STAFF REPORT**COMMUNITY DEVELOPMENT DEPARTMENT**

SUBJECT: FP-2020-0006
Movado No. 9

A final plat consisting of thirty-four (34) building lots, six (6) common lots, and one (1) common drive on 7.47 acres of land in the R-15 zoning district. *This is the ninth and final phase of development of the Movado Estates Subdivision (H-2016-0112).*

MOVADO SUBDIVISION NO. 9
LOCATED IN THE NE1/4 OF SECTION 21,
T. 3 N., R. 1 E., B.M., CITY OF MERIDIAN, ADA COUNTY, IDAHO
2020

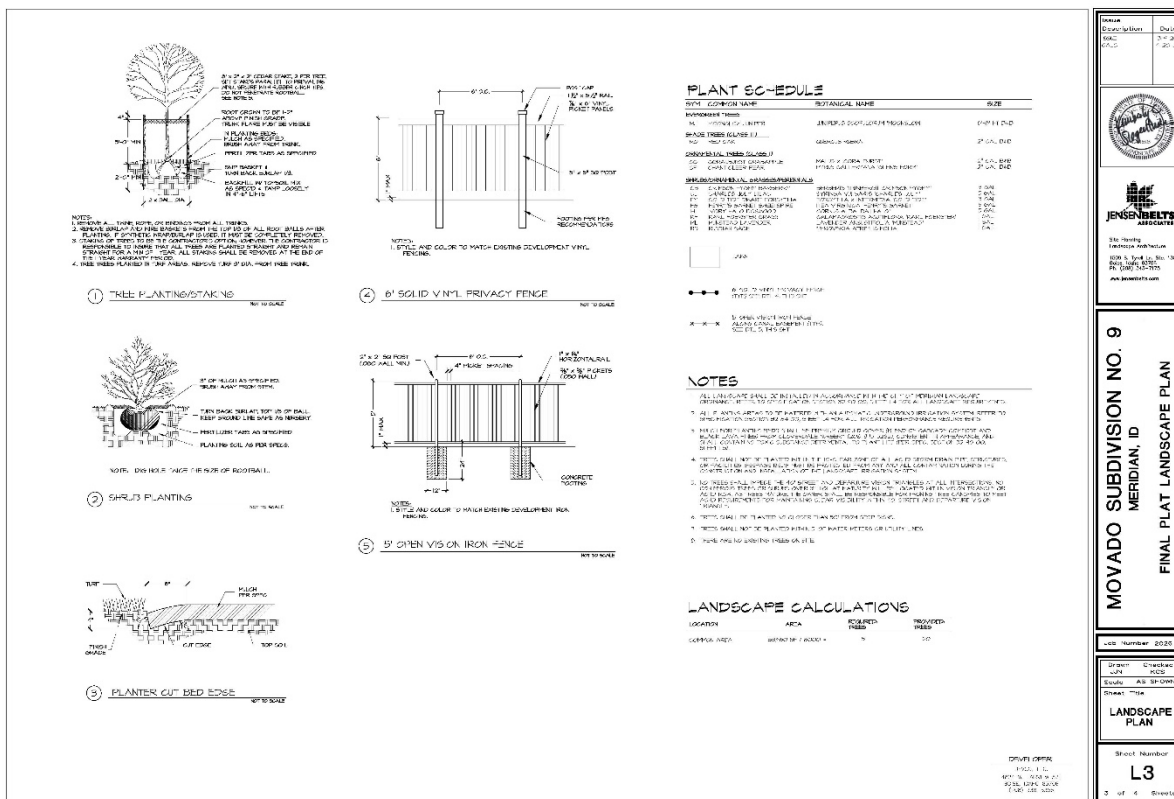
3. Prior to submittal for the City Engineer's signature, have the Certificate of Owners and the accompanying acknowledgement signed and notarized.
4. Prior to signature on the final plat by the City Engineer, the final plat prepared by Sawtooth Land Surveying, LLC (Exhibit B), dated September 16, 2020, shall be revised as follows:

- a. Add a note stating "This subdivision is subject to the provisions contained in City of Meridian Development Agreements Inst. #2017-012608 & 2017-024757.

- b. Note #15: Include recorded access easement instrument number.
 - c. Add a common lot at least 25-feet wide along Cloverdale Road to contain the required landscape buffer.

FINAL PLAT LANDSCAPE PLAN

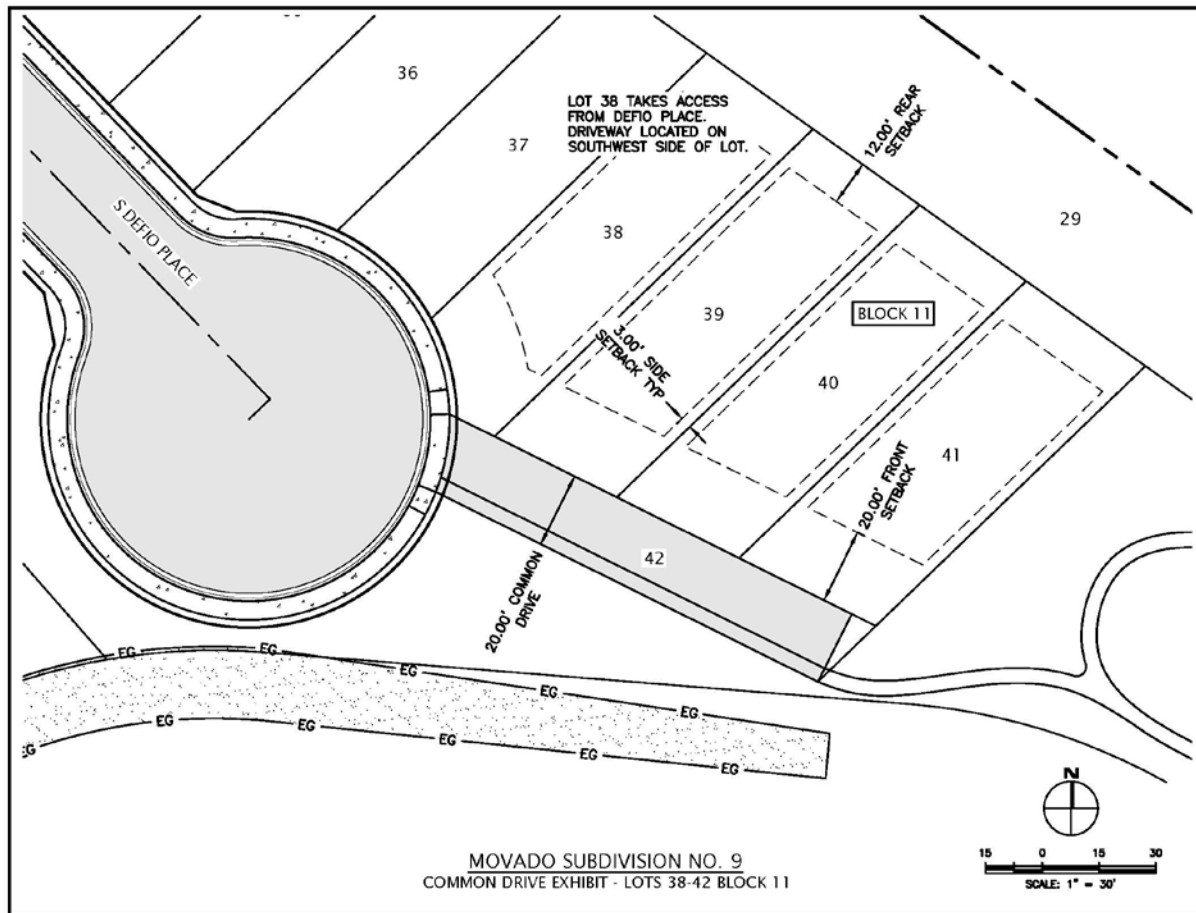
5. Prior to signature on the final plat by the City Engineer, the landscape plan prepared by Jensen Belts Associates (Exhibit C), dated April 20, 2020, shall be revised as follows:

- a. Revise the common open space lot layout of Lots 43 & 44, Block 11 to match the lot layout on the submitted Final Plat and include a common lot for the required landscape buffer along Cloverdale Road.

- b. Show the required 25-foot landscape buffer along Cloverdale Road vegetated per the standards in UDC 11-3B-7.
 - c. Revise the fencing shown along the Ridenbaugh Canal to depict 5-foot open vision fencing as approved with the preliminary plat and as required in UDC 11-3A-7.

- d. Show the proposed amenity in Lot 43, Block 11 to be more consistent with the landscape plan approved with the preliminary plat application and per the approved Development Agreement provisions, and provide an electronic copy of exhibits of the required outdoor fitness equipment as approved with the preliminary plat application to Planning Staff.
